PIC18F06/16Q41 Silicon Errata and Data Sheet Clarifications

The PIC18F06/16Q41 devices you have received conform functionally to the current device data sheet (DS40002214E), except for the anomalies described in this document.

1.5.1 UART TXDE Signal May Go Low Before the STOP Bit Has Been Entirely Transmitted

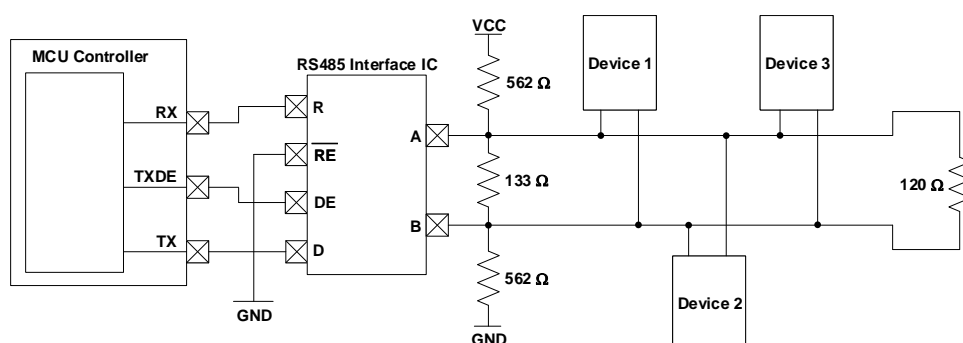
The UART Transmit Drive Enable (TXDE) signal could potentially transition into a low state before the UART STOP bit has been entirely transmitted due to the effects of parasitic capacitance on the TX line. In some applications, this could result in communication being prematurely terminated due to the TXDE bit going low before the STOP bit has had enough time to settle.

To ensure that the STOP bit settles into its final logic state before the TXDE signal transitions low, a biasing circuit can be implemented. A biasing circuit allows the TX line to either be driven high or low, rather than being left in a floating tri-state mode where prolonged rise or fall times could lead to communication being disrupted. This bias circuit should only be implemented on one end of the serial bus, and a termination resistor should be used on the other end. The figure below shows an example of a bias circuit that can be used to achieve this.

Please note that the resistor values used in this circuit are recommendations, and that the actual resistor values required may vary based on the application.
